STAFF REPORT AND RECOMMENDATION

Planning Commission Hearing: August 26, 2019

FILE NUMBER: **GLUA-18-00031 General Land Use Application:** SP 18-00119 Site Plan and Design Review, PARK 18-00001 Parking Adjustment, and VAR-18-00002 Variance

REQUEST: The applicant requests a Parking Adjustment to exceed the maximum number of parking spaces allowed, along with development of a parking lot expansion and variance for new parking spaces located in front of the existing building.

Figure 3: Proposed Site Plan

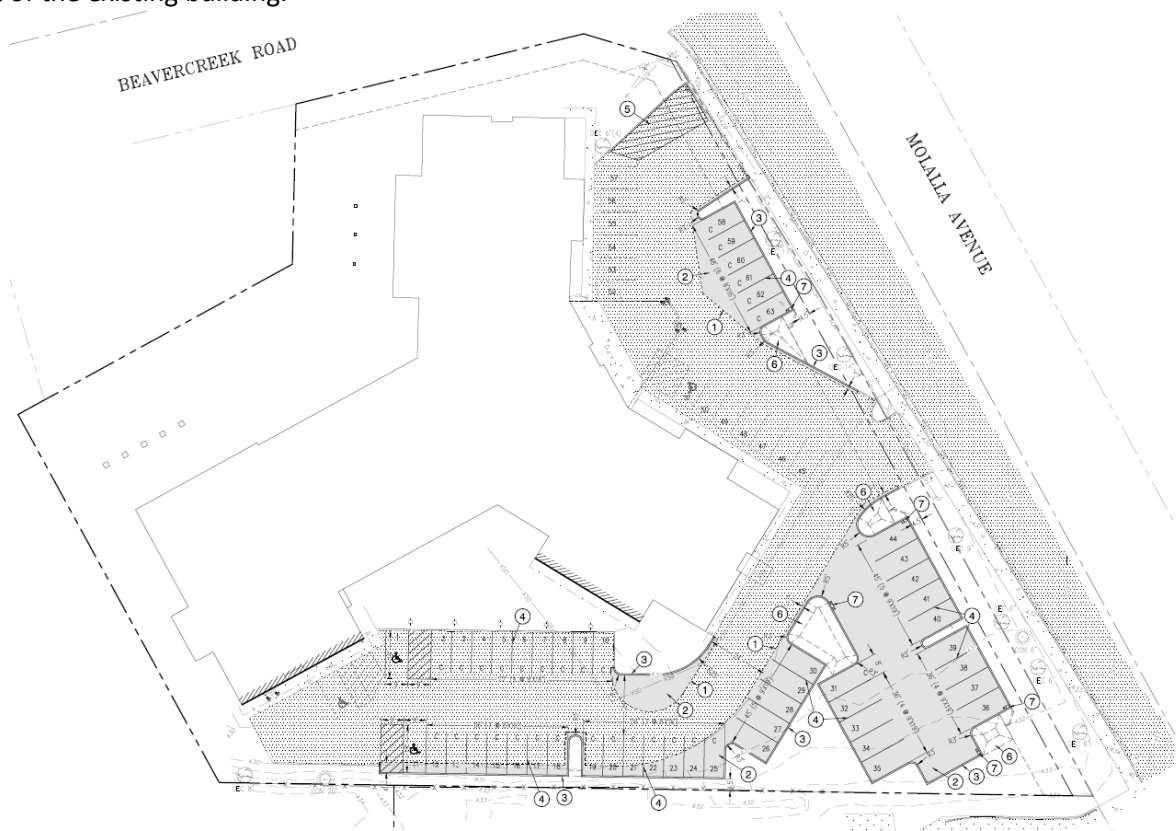
Finding: Complies with conditions. The existing driveways exceed 24 feet in width and they are not aligned with existing or planned streets. The applicant shall redesign the northernmost driveway to reduce its width and provide only right-in right-out access. The final width shall be determined by the city engineering staff in consultation with emergency service providers. **Staff has determined that it is possible, likely and reasonable that the applicant can meet this standard through the Conditions of Approval.**

Finding: Complies with condition. A pedestrian connection from the public sidewalk to the entrance has not been provided; nor has a pedestrian connection to the new parking area on the southeast corner of the property been proposed. Pedestrian upgrades are required as part of nonconforming upgrades. The applicant shall provide pedestrian connections from the sidewalk to the front entrance and from the existing walkway in front of the building to the new parking area proposed in the southeast portion of the site. **Staff has determined that it is possible, likely and reasonable that the applicant can meet this standard through the Conditions of Approval.**

Finding: Complies with condition. The applicant's narrative identified that the proposed bicycle parking would be next to the building but did not show it on the site plan. Prior to issuance of permits, the

18. The applicant shall redesign the northernmost driveway to reduce its width and provide only right-in right-out access. The final width shall be determined by the city engineering staff in consultation with emergency service providers. The applicant shall install signing in conformance with the Manual on Uniform Traffic Control Devices. The southernmost driveway shall be reconstructed to limit ingress and egress to only right turn maneuvers to and from Molalla Avenue; the driveway shall be signed in conformance with the Manual on Uniform Traffic Control Devices. (P)

21. The applicant shall provide pedestrian connections from the sidewalk to the front entrance and from the existing walkway in front of the building to the new parking area proposed in the southeast portion of the site. The applicant shall ensure that the required connections meet all of the requirements in 17.62.050.A.9.f. (P)

24. Prior to issuance of permits, the applicant shall include bicycle parking on the site plan and show details demonstrating that the parking is securely anchored in a convenient, secure, and accessible location, that the parking is separated from vehicle parking and maneuvering areas by 5 feet and does not obstruct pedestrian walkways, and is clearly marked or visible from the street, is connected to main building entrances, has direct access from a right of way, and is closer to the building than the nearest vehicle parking. (P)

Figure 4. Proposed Landscaping Plan

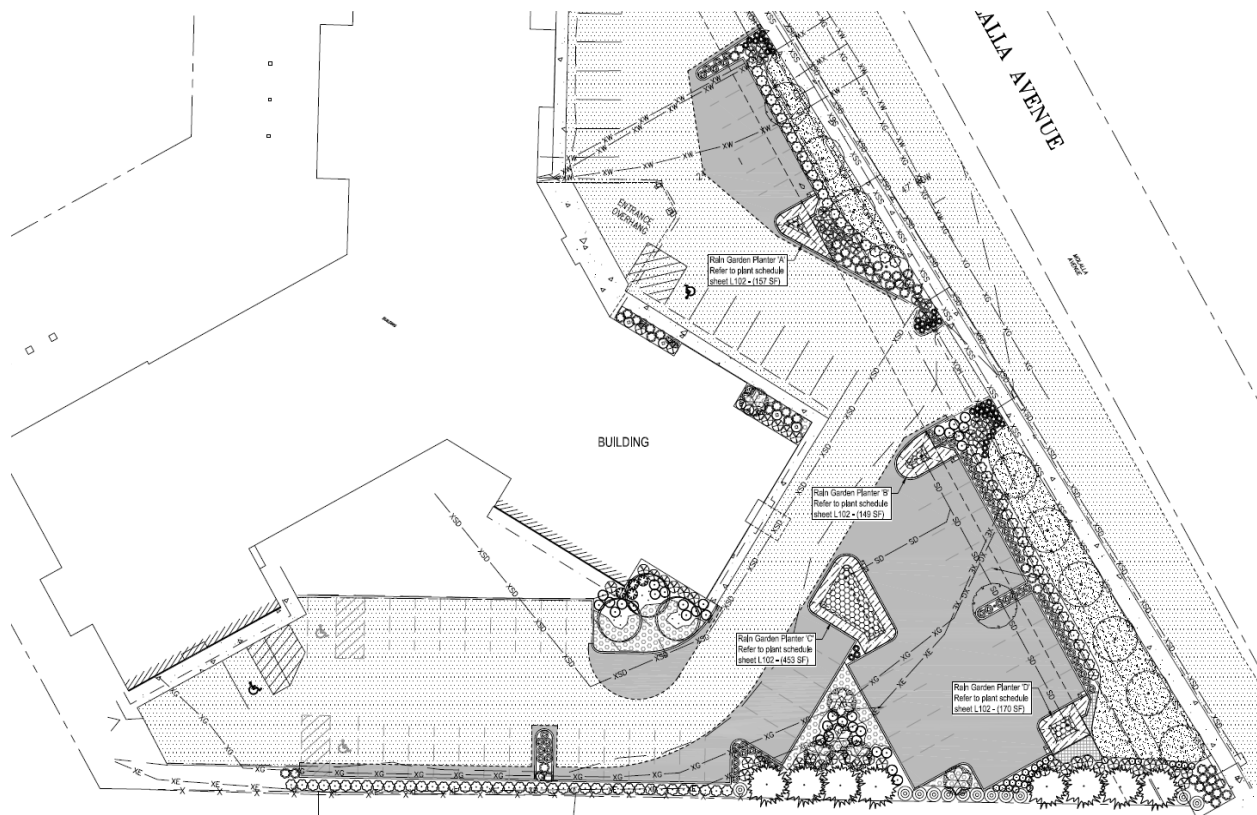
Finding: Complies with Condition. The landscape plan was prepared by Troy Mears, Registered Landscape Architect. The plan includes a mix of vertical and horizontal elements but it does not identify that the proposed plantings will cover 100% of the landscape area within 3 years nor that no mulch, bark chips, or similar materials will be allowed at the time of landscape installation except under the canopy of shrubs and within two feet of the base of trees. Prior to issuance of permits, the applicant shall revise the landscaping plan meet this standard. **Staff has determined that it is possible, likely and reasonable that the applicant can meet this standard through the Conditions of Approval.**

Finding: Complies with Condition. The landscaping plan does not indicate any irrigation and the applicant did not submit an alternative plan. Prior to issuance of permits, the applicant shall demonstrate that irrigation will be included or propose an alternative that is acceptable to the Community Development Director. **Staff has determined that it is possible, likely and reasonable that the applicant can meet this standard through the Conditions of Approval.**

Finding: Complies with Condition. The plan submitted by the applicant was prepared by a landscape architect to assure appropriate species. One of the species, a Portuguese laurel, is the same or similar to a species on the City's nuisance plant list. Prior to issuance of permits, the applicant's landscape architect shall ensure that the Portuguese laurel species is not a nuisance species. **Staff has determined that it is possible, likely and reasonable that the applicant can meet this standard through the Conditions of Approval.**

Finding: Complies with condition. The landscaping plan includes a 5-foot wide landscape buffer along all new perimeter parking lot areas. There are two existing mature trees in front of the building that are in the area where perimeter parking lot landscaping is proposed. If the applicant wishes to and is able to preserve the two trees instead of removing them to provide a reconfigured parking lot and landscaping area, the perimeter parking lot landscaping may be reduced or removed in this area through an alternative landscaping plan. The preserved trees and landscape around them will provide sufficient landscaping to meet the intent of this standard. If the trees are removed, the proposed perimeter landscaping meets this standard. **Staff has determined that it is possible, likely and reasonable that the applicant can meet this standard through the Conditions of Approval.**

17. The applicant shall revise the landscaping plan to identify that the proposed plantings will cover 100% of the landscape area within 3 years nor that no mulch, bark chips, or similar materials will be allowed at the time of landscape installation except under the canopy of shrubs and within two feet of the base of trees. (P)

27. If the applicant wishes to preserve the two trees, along with the existing monument sign on the Molalla Avenue frontage, the perimeter parking lot landscaping may be reduced or removed in this area. The preserved trees and landscape around them will provide sufficient landscaping to meet the intent of this standard. (P)
